**From:** Levine, Cody <CLevine@worcestershire.gov.uk>  
**Sent:** 05 June 2020 14:56  
**To:** Aldridge, Steven <SAldridge@worcestershire.gov.uk>  
**Subject:** RE: Lea Castle Quarry Queries

## PRELIMINARY ECOLOGICAL APPRAISAL OF LAND AT LEA CASTLE FARM, WOLVERLEY

#### BAT ROOST SURVEY AT LEA CASTLE FARM, WOLVERLEY

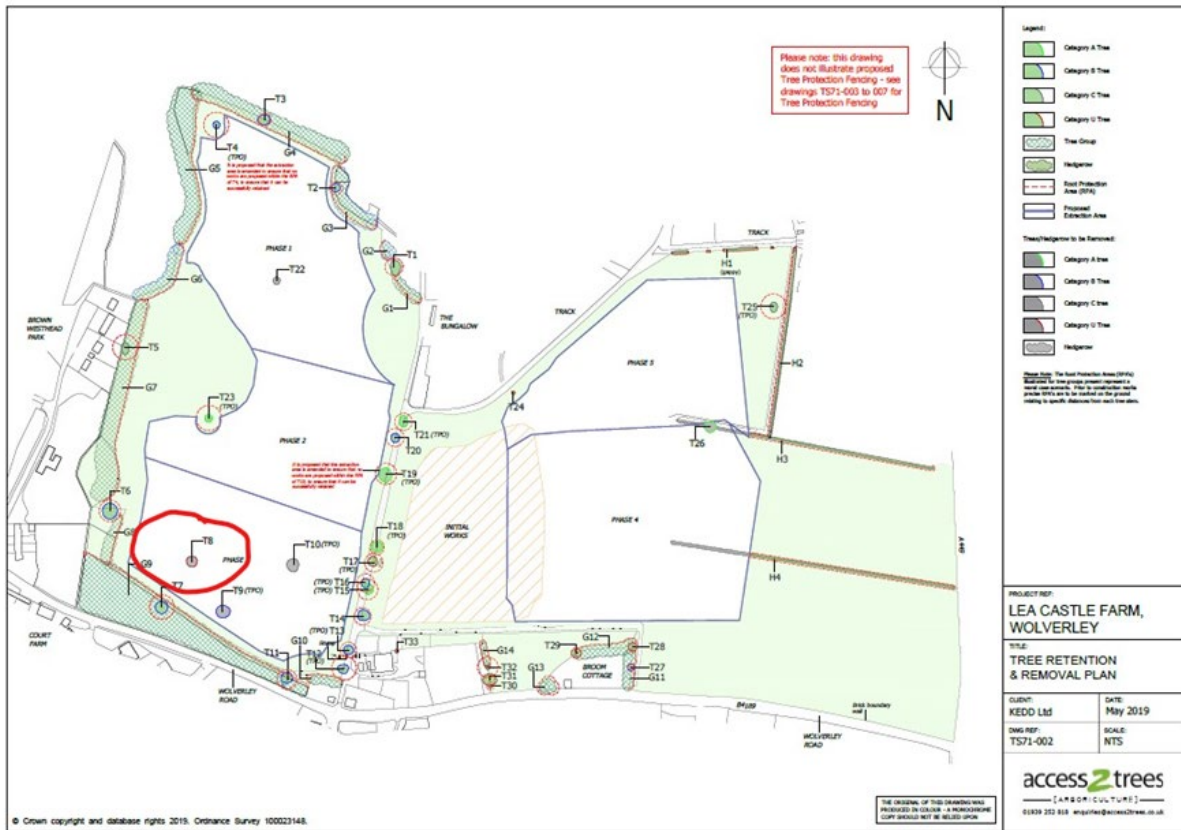
Sorry, you're quite right, there seems to be a confusing mismatch in tree ID between the various documents, specifically between the ecology and arboricultural appendices. I'd not noticed this until I went back to cross-reference the two documents, and it's thrown up some more questions.

- Target Note 2 as a dying sweet chestnut with negligible bat roost potential. This tree's identified as T22 (**veteran** sweet chestnut) in the arboricultural report.

- Target Note 3 is identified as a **veteran** oak in poor condition and which apparently hasn't been assessed any further for potential to support bat roosts. I believe this tree is T5 in the arboricultural report, but was not identified in that document as a veteran tree.

- Target Note 5 is tree T3, identified as a sweet chestnut with moderate bat roosting potential and which was subsequently found to support a bat roost. Unless I've mis-read the reports, I think this tree is identified as T8 in the arboricultural report, which identifies it as a common oak?

- Target Note 6 is tree T2, an oak with high bat roost potential and subsequently a 'possible' bat emergence was noted during surveys. This is identified as T9 in the arb report.

- Target Note 12 is tree T4, an oak tree with high bat roost potential and which supports roosting kestrel. This was identified as **veteran** oak T25 in the arb report.

I think my point applies regardless of species and bat roost: development resulting in loss or deterioration of veteran trees (T5, T22 and T25 as per arboricultural report, based on combined assessment btwn the applicant's ecologists and arboriculturists) shouldn't be permitted unless there are wholly exceptional reasons and an acceptable compensation strategy exists.

As a related point, Target Note 3 (in the PEA) is identified as a veteran oak (I believe this is T25 in the arb report, which also identifies the tree as a veteran oak) and I could see no assessment of bat roost potential. I think consideration of effects on T25 is pertinent as the tree is located very close to site boundaries and may, as a result, be affected by draw-down, dust, noise/vibration, light or other effects of the scheme during operation/restoration which may in turn lead to deterioration and potential loss. Further clarification is therefore sought to consideration of effects on and protection measures for veteran oak tree TN3/T25.
